ADDENDUM 01

Project Name: Oceanside Place - AHU Replacement - 2017

Date: July 25, 2017

Project Number: 17177-N

Refer to Structural Drawing S101 (1 Page Attached)

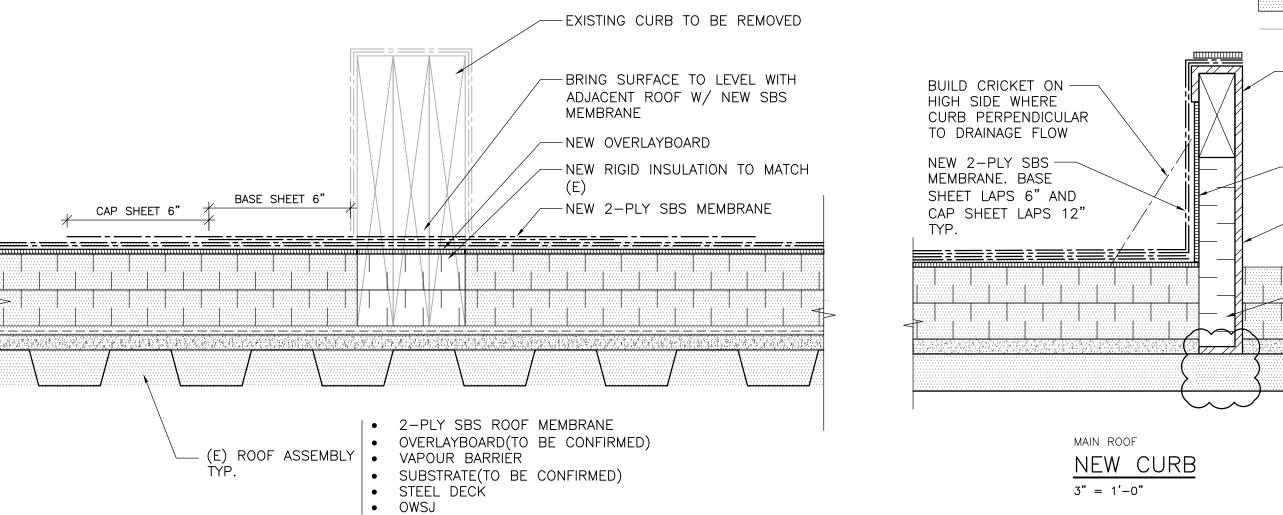
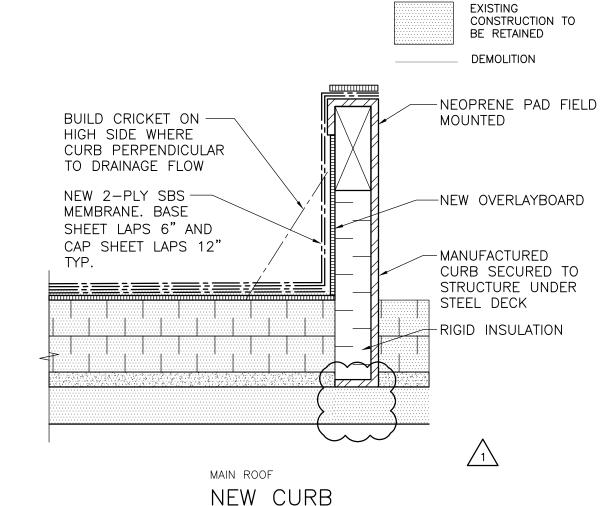
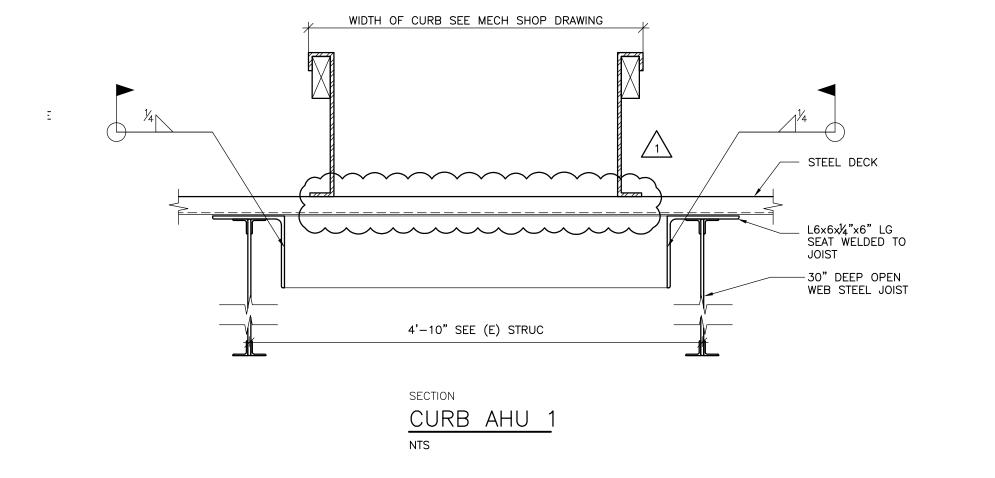
CLARIFY: To clarify, the structural details on drawing S101 refer only to AHU-1.

REVISE: Revise drawing as shown. Changes are shown in revision clouds.
